## **Proposed Code Modifications**

# TAC: Energy

## Sub Code: Energy Conservation

EN6924

**Responsible Energy Codes Alliance Comment on Proposal EN6573**

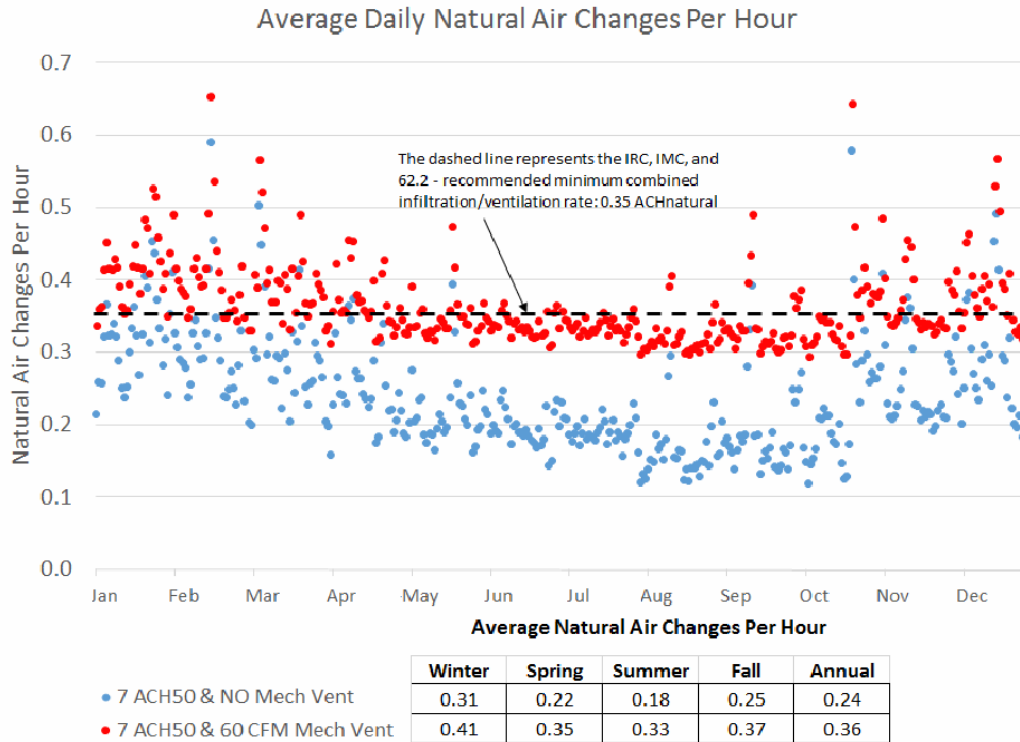
To insure that occupants are able to receive the minimum combined infiltration and ventilation rate promulgated by model codes and standards (i.e., 0.35 natural air changes per hour), the air leakage target should not be increased without simultaneously requiring mechanical ventilation. This comment proposes to continue to require mechanical ventilation if Florida elects to increase the air tightness target to 7 ACH50.

Following is a chart created using DOE's EnergyPlus software that shows the average daily combined infiltration and ventilation rate for a typical 2,600 ft<sup>2</sup> three-bedroom, single-family home located in Orlando. The chart examines daily, seasonal, and annual average combined infiltration and ventilation rates for the same typical home across two scenarios:

Under Scenario A (7 ACH 50 with no mechanical ventilation), the average annual air change rate is 0.24 natural air changes per hour, frequently dipping below 0.15 in the summer months. Research has shown that formaldehyde emissions from building materials increase with increasing temperature and relative humidity, and formaldehyde concentrations increase with decreasing infiltration/ventilation rates. In other words, formaldehyde emissions and concentrations are likely to spike in the summer under Scenario A when natural infiltration is at its lowest. Resultant poor indoor air quality can significantly diminish occupants' health. In fact, research suggests that poor IAQ is responsible for around \$500 annually in health related costs per person in the U.S., which translates to \$10 billion annually in Florida.\*

Under Scenario B, as proposed by this comment, tightening the building envelope to 7 ACH50 and providing mechanical ventilation would achieve the minimum annual average combined infiltration and ventilation rate of 0.35 natural air changes per hour. Scenario B would also provide more balanced ventilation across the year, registering 0.33 natural air changes per hour in the summer and providing more protection to occupants from higher levels of formaldehyde expected to be experienced during this season.

**Responsible Energy Codes Alliance Comment on Proposal EN6820**

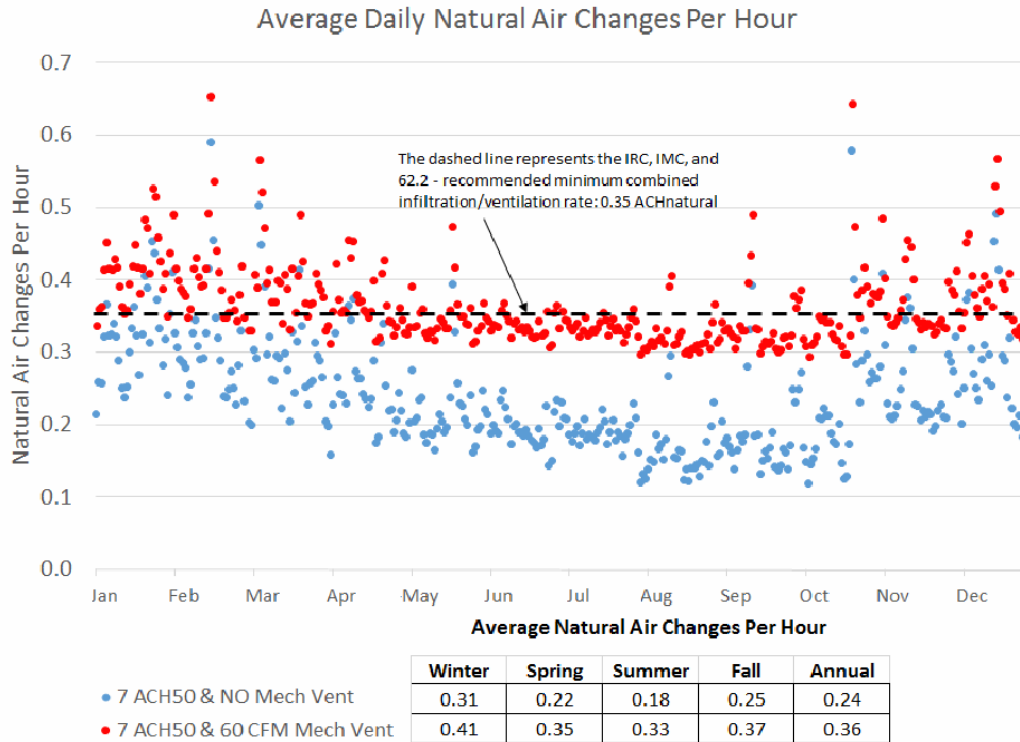
Following is a chart created using DOE's EnergyPlus software that shows the average daily combined infiltration and ventilation rate for a typical 2,600 ft<sup>2</sup> three-bedroom, single-family home located in Orlando. The chart examines daily, seasonal, and annual average combined infiltration and ventilation rates for the same typical home across two scenarios:

Under Scenario A (7 ACH 50 with no mechanical ventilation), the average annual air change rate is 0.24 natural air changes per hour, frequently dipping below 0.15 in the summer months. Research has shown that formaldehyde emissions from building materials increase with increasing temperature and relative humidity, and formaldehyde concentrations increase with decreasing infiltration/ventilation rates. In other words, formaldehyde emissions and concentrations are likely to spike in the summer under Scenario A when natural infiltration is at its lowest. Resultant poor indoor air quality can significantly diminish occupants' health. In fact, research suggests that poor IAQ is responsible for around \$500 annually in health related costs per person in the U.S., which translates to \$10 billion annually in Florida.\*

Under Scenario B, as proposed by this comment, tightening the building envelope to 7 ACH50 and providing mechanical ventilation would achieve the minimum annual average combined infiltration and ventilation rate of 0.35 natural air changes per hour. Scenario B would also provide more balanced ventilation across the year, registering 0.33 natural air changes per hour in the summer and providing more protection to occupants from higher levels of formaldehyde expected to be experienced during this season.

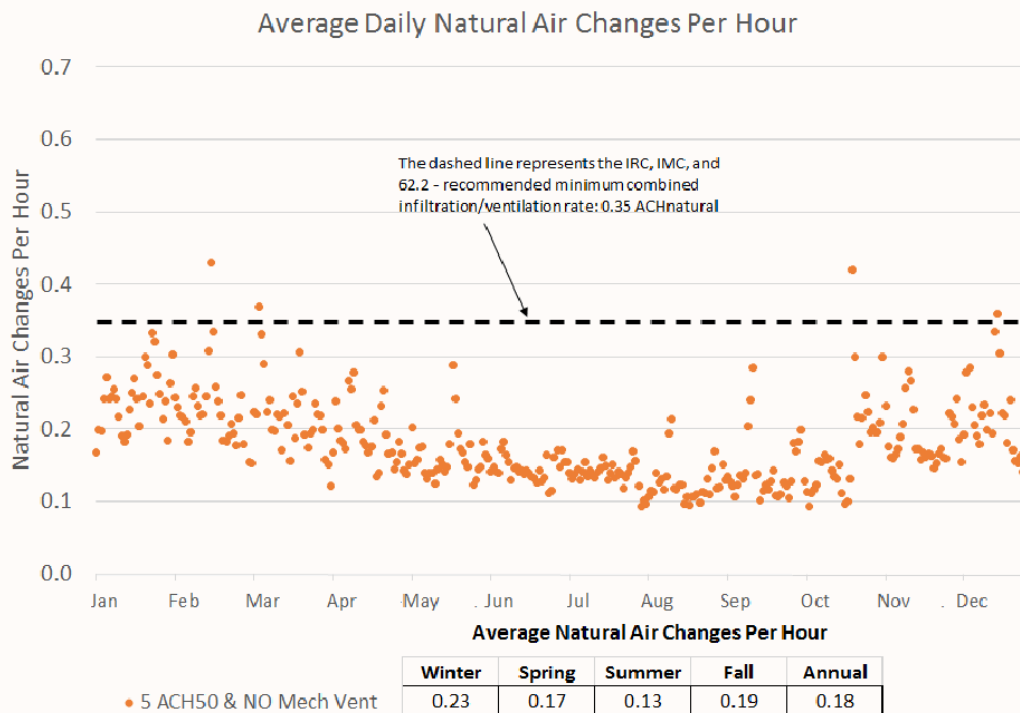
Recommend disapproval of this proposal. The proposal’s rationale states that its intent is to clarify “that mechanical ventilation is not necessary.” The proponent provides no technical basis to support this claim, which runs counter to engineering calculations and research showing that natural ventilation and infiltration are insufficient to achieve acceptable indoor air quality.

As an example, following is a chart created using DOE’s EnergyPlus software that shows the average daily combined infiltration and ventilation rate for a typical 2,600 ft<sup>2</sup> three-bedroom, single-family home located in Orlando with a building air tightness of 5 ACH50 and *no* mechanical ventilation. The average annual natural air change rate for this typical home is 0.18 (just over half of the 0.35 air changes per hour promulgated by model codes and standards), with a seasonal low of 0.13 in the summer. Research has shown that formaldehyde emissions from building materials increase with increasing temperature and relative humidity, and formaldehyde concentrations increase with decreasing infiltration/ventilation rates. In other words, formaldehyde emissions and concentration are likely to spike in the summer when natural infiltration is at its lowest. Resultant poor indoor air quality can significantly diminish occupants’ health. In fact, research suggests that poor IAQ is responsible for around \$500 annually in health related costs per person in the U.S., which translates to \$10 billion annually in Florida.\*
